New Surface Parking Lot

11/10/2017

ADDENDUM #3

Landscape Addendum #3 Narrative

SHEET 2		CITY OF OCEANSIDE OF 13	
LANDSCAPE ARCHITECTURAL PLANS FOR:			
TCMC PARKING LOT			
4002 VISTA WAY			
OCEANSIDE, CALIFORNIA			
Approved			
CITY ENGINEER	STEVE STRAPAC RCE 57654	DATE	
LANDSCAPE ARCHITECT OF WORK	YU-JU LIU 5145	Checked by	
NAME OF LA	R.L.A.S	Approval date	L1.01

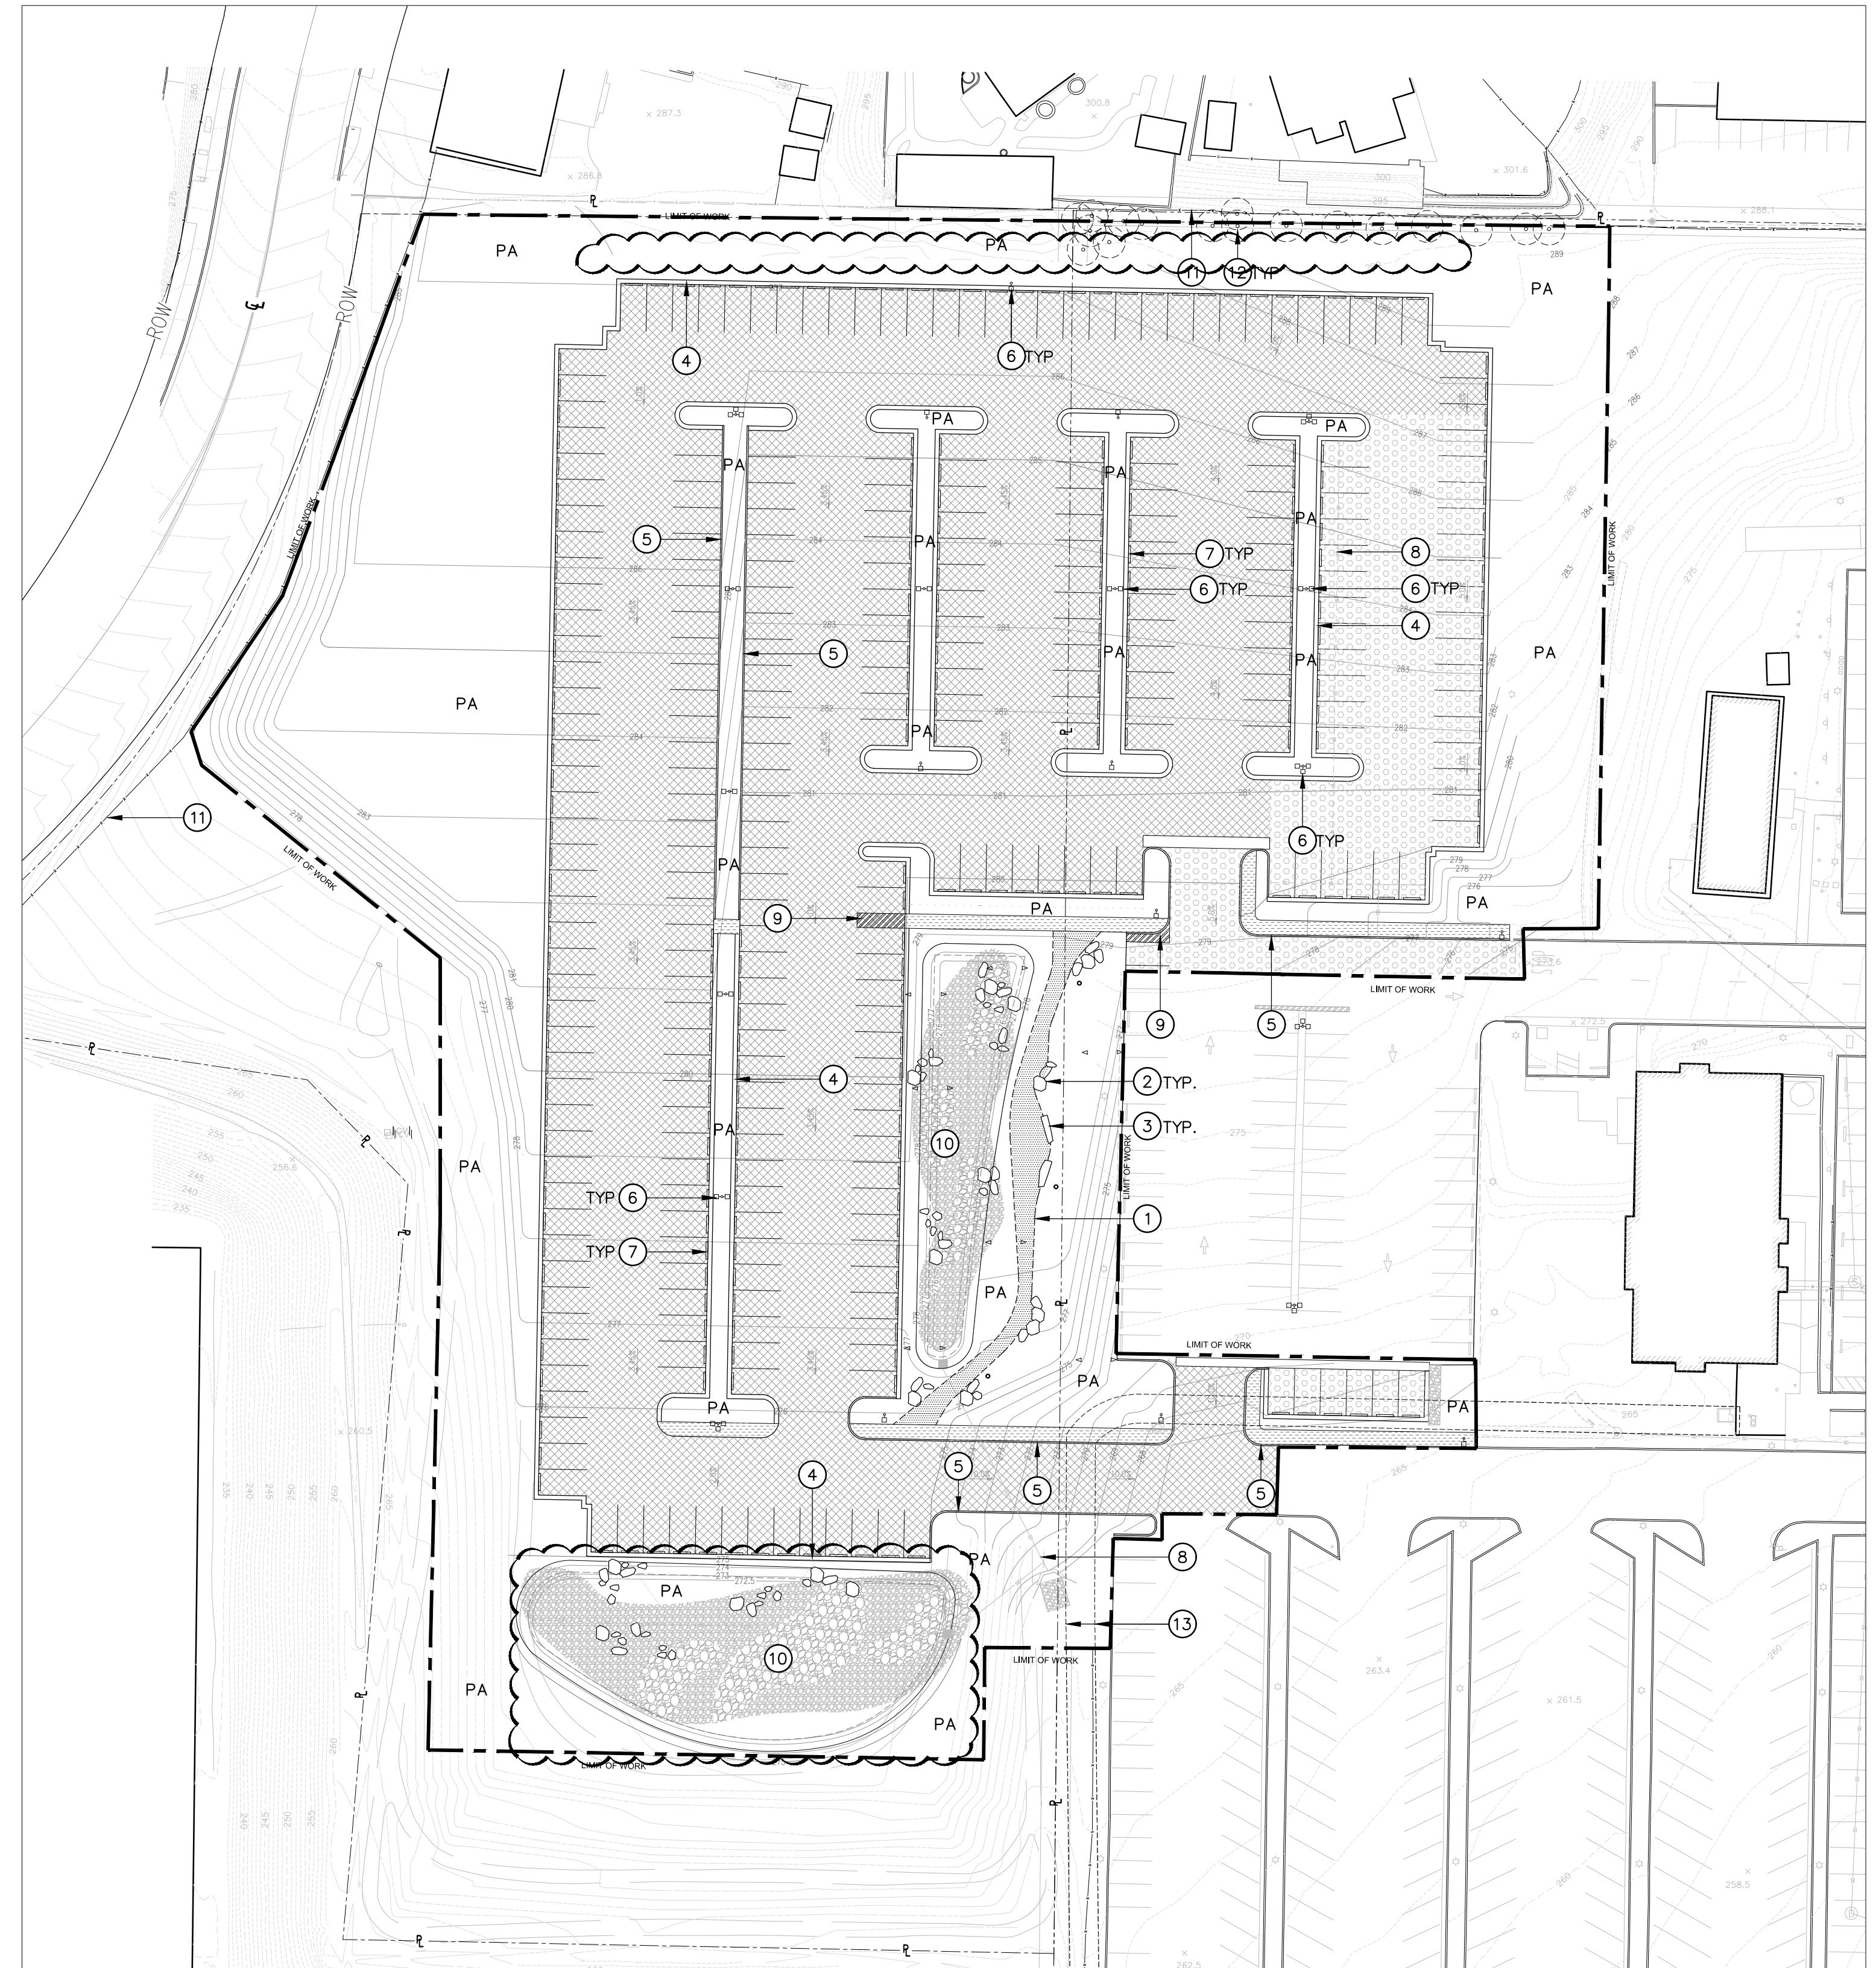
Page	Changes
L1.01 Site plan	<ul style="list-style-type: none"> 1. Hardscape legend updated with detailed information 2. Removed 6' high CMU concrete wall per the Owner 3. Bioswale gravel pattern changed
L1.02 Hardscape details	<ul style="list-style-type: none"> 1. Add construction details for all hardscape elements. 2. Removed the detail of the 6' high screen wall
L2.01	Updated Irrigation plan to include pipe sizing, valves and further design information
L2.02	Updated Irrigation plan to include pipe sizing, valves and further design information
L2.03	Updated Irrigation equipment list
L2.04	Add Irrigation caculation and schedule
L3.01	<ul style="list-style-type: none"> 1. Further development of planting design 2. Locations of trees were updated per City's comment
L3.02	<ul style="list-style-type: none"> 1. Further development of planting design 2. Locations of trees were updated per City's comment

L3.03 PLANTING NOTES AND LEGEND

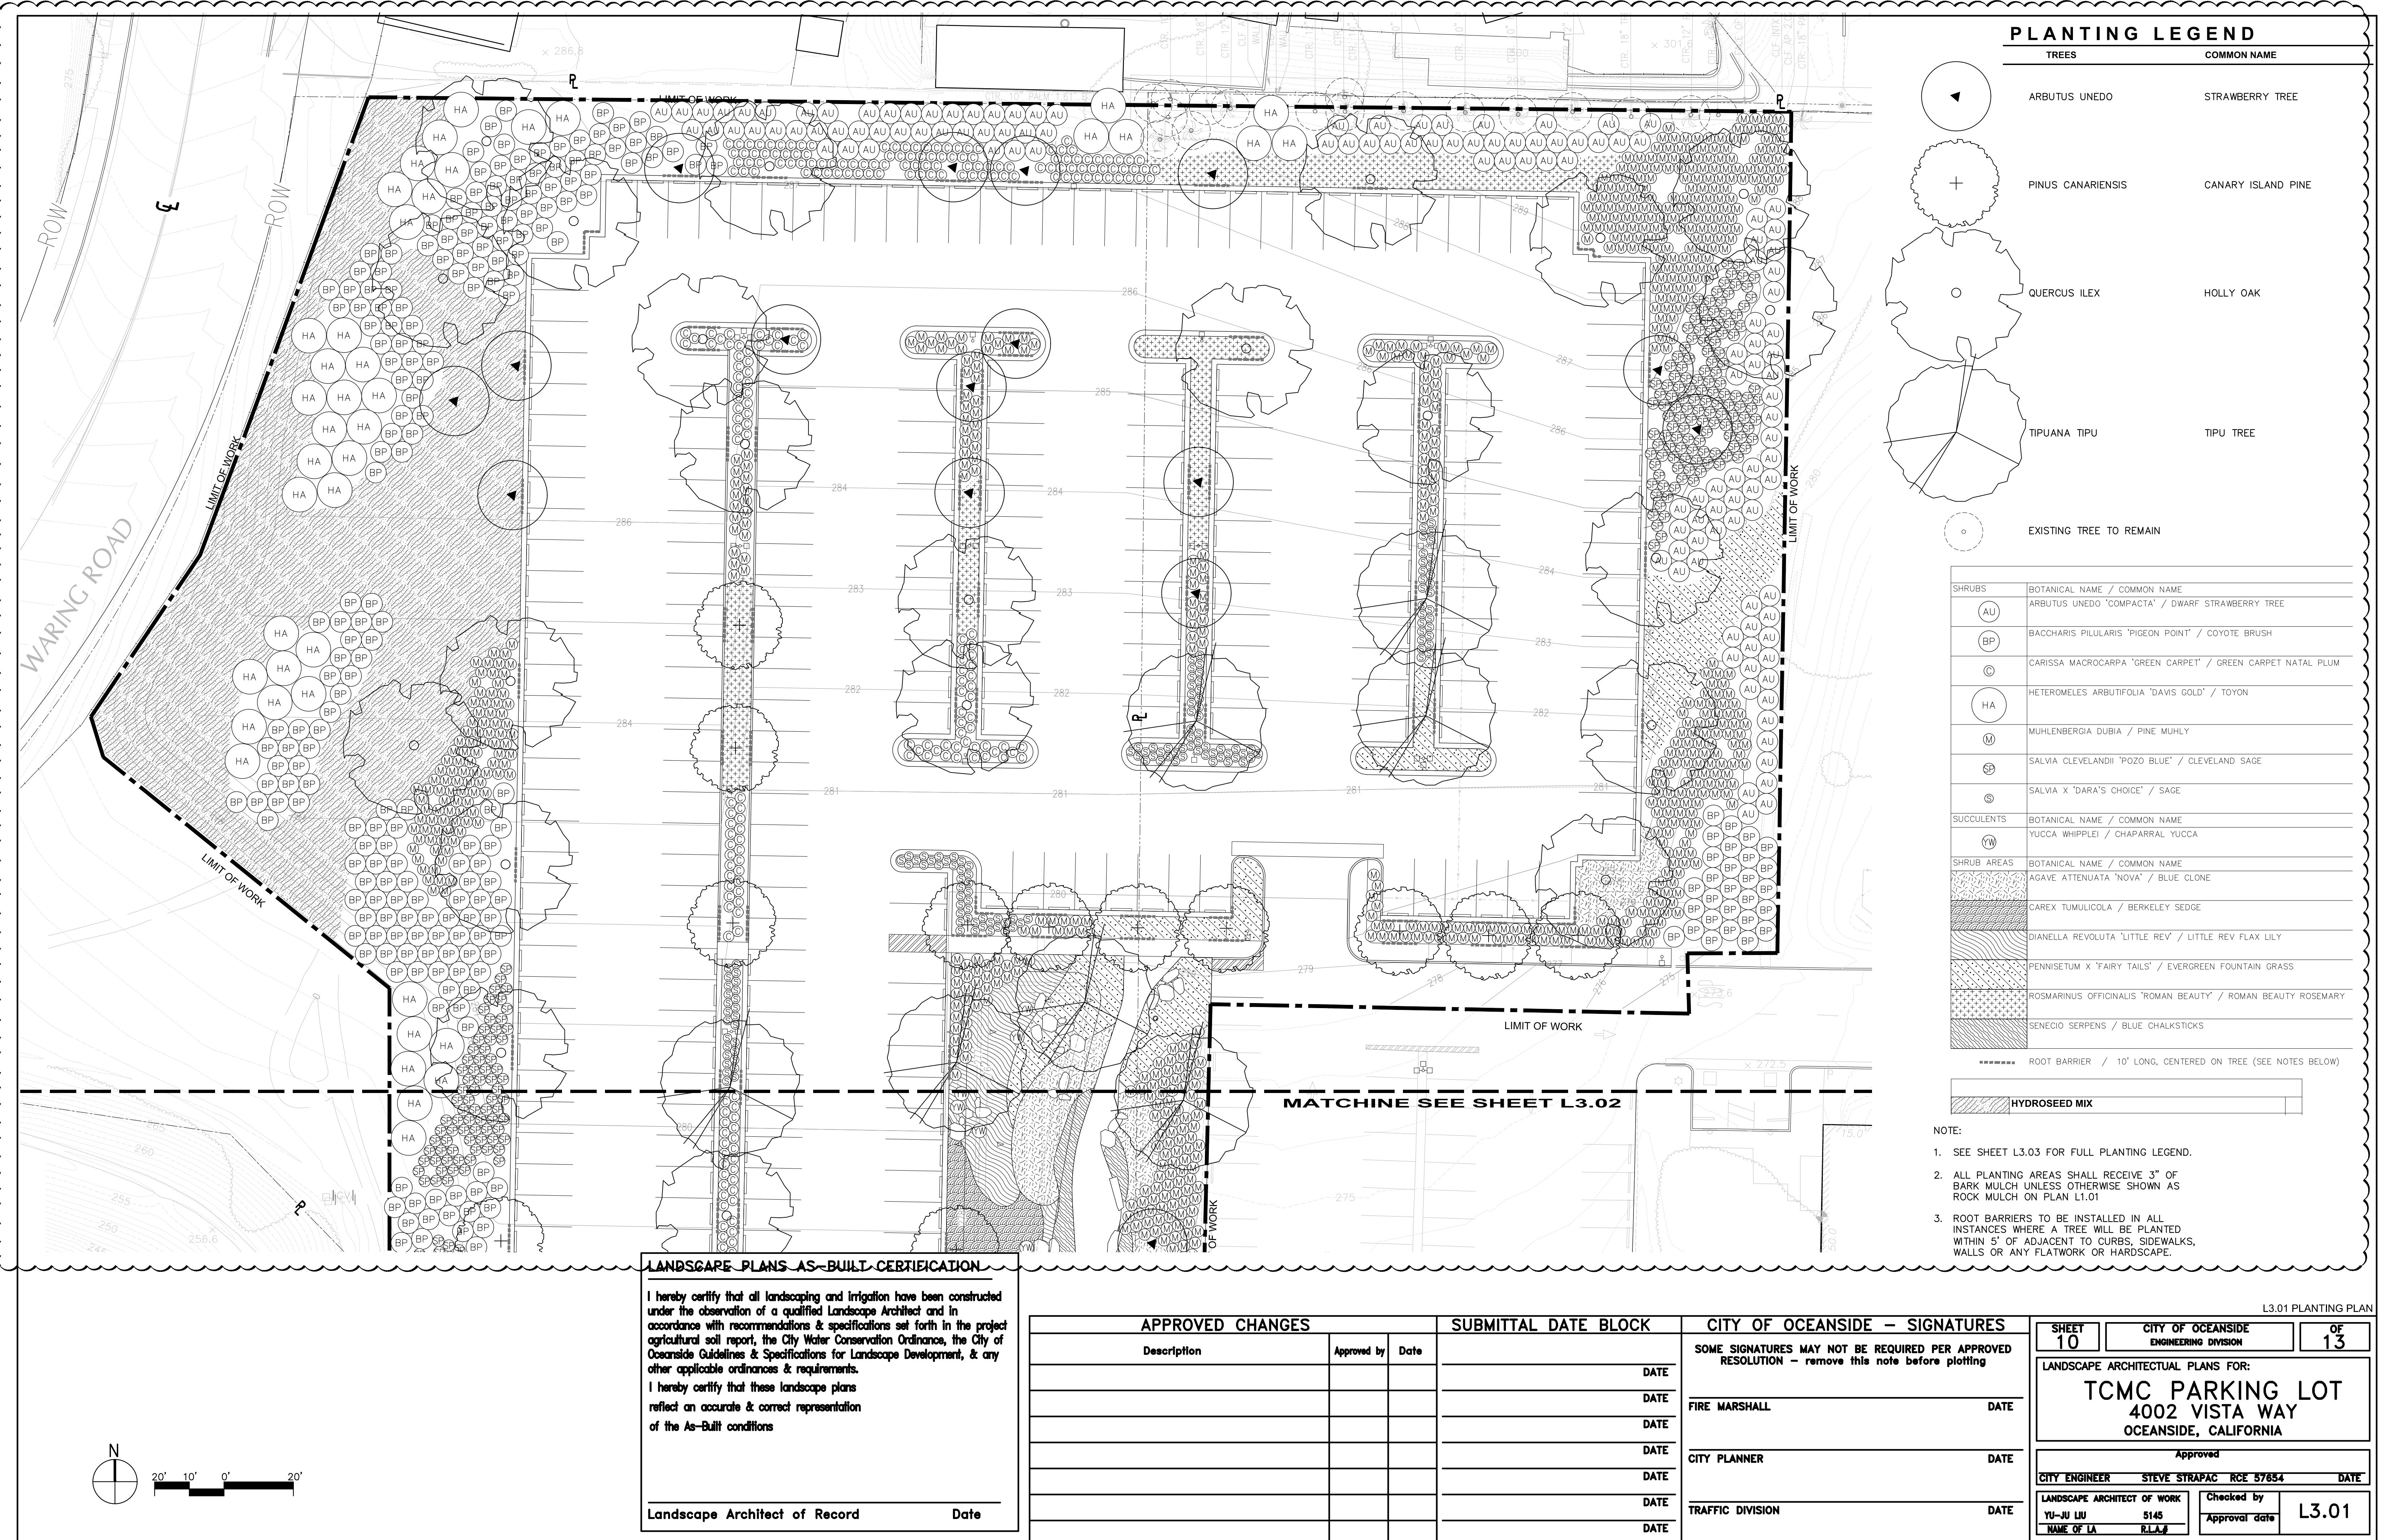
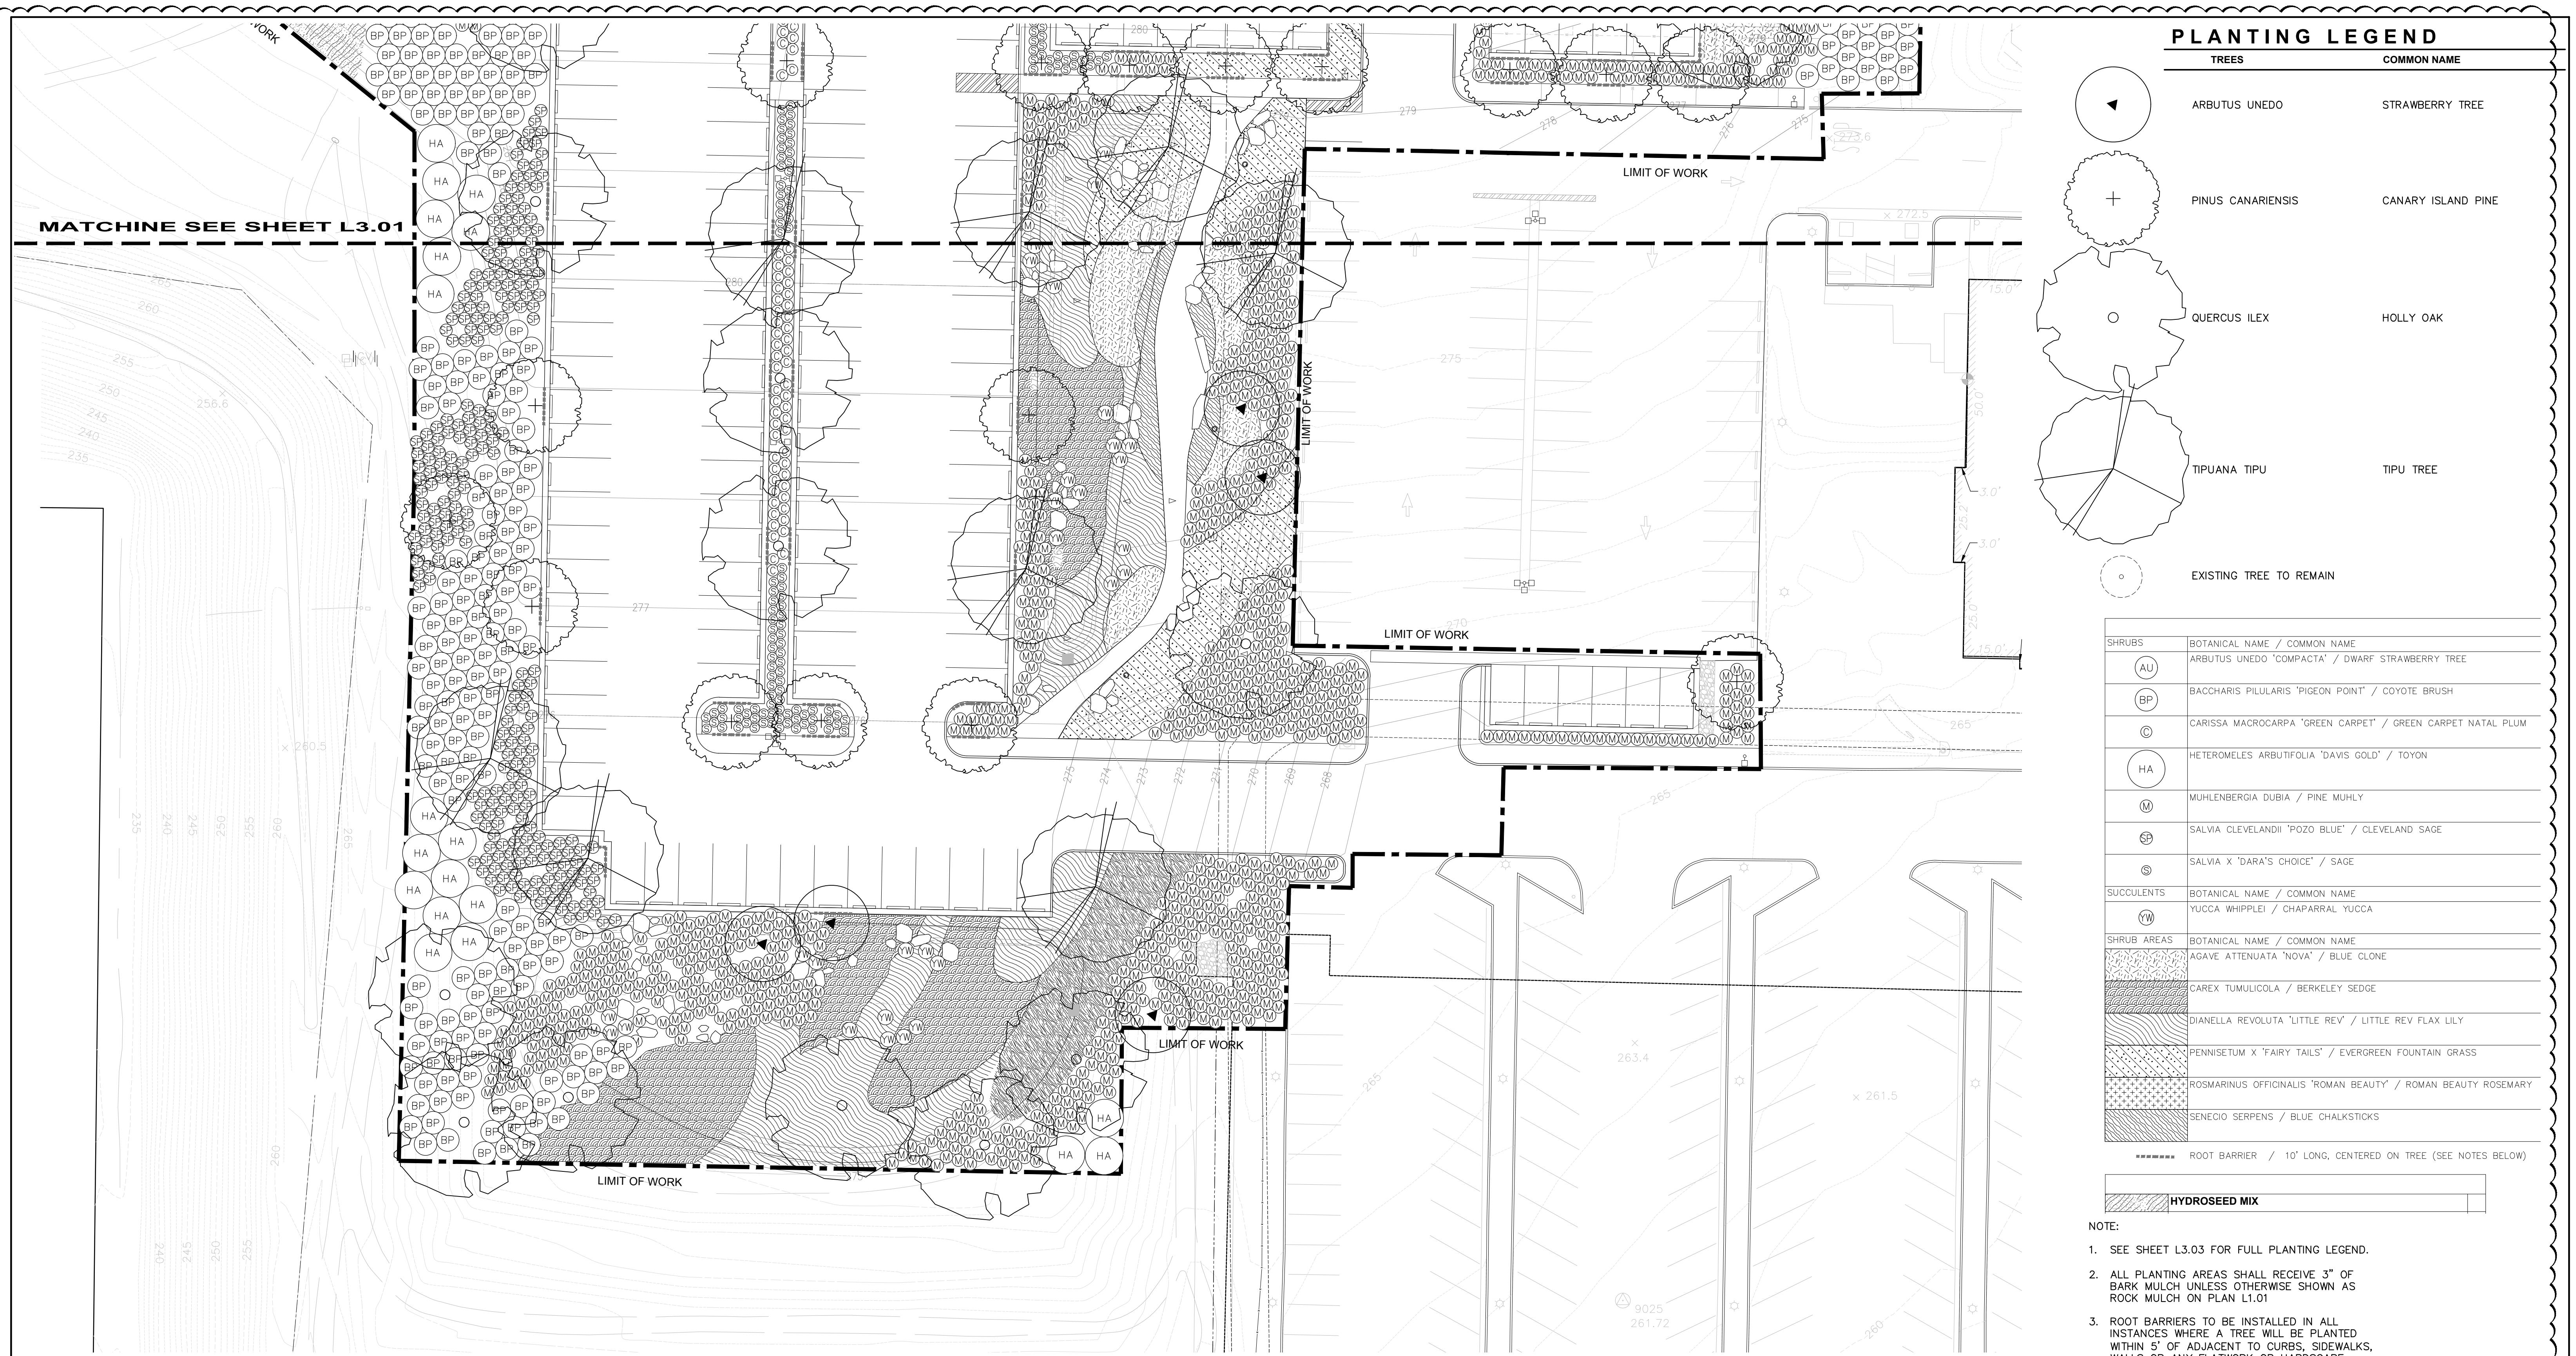
L3.03	Update Planting size, spacing and quantity. Provide complete information for hydroseed mix design.
L3.04	Add construction details for tree/shurb/groundcover.
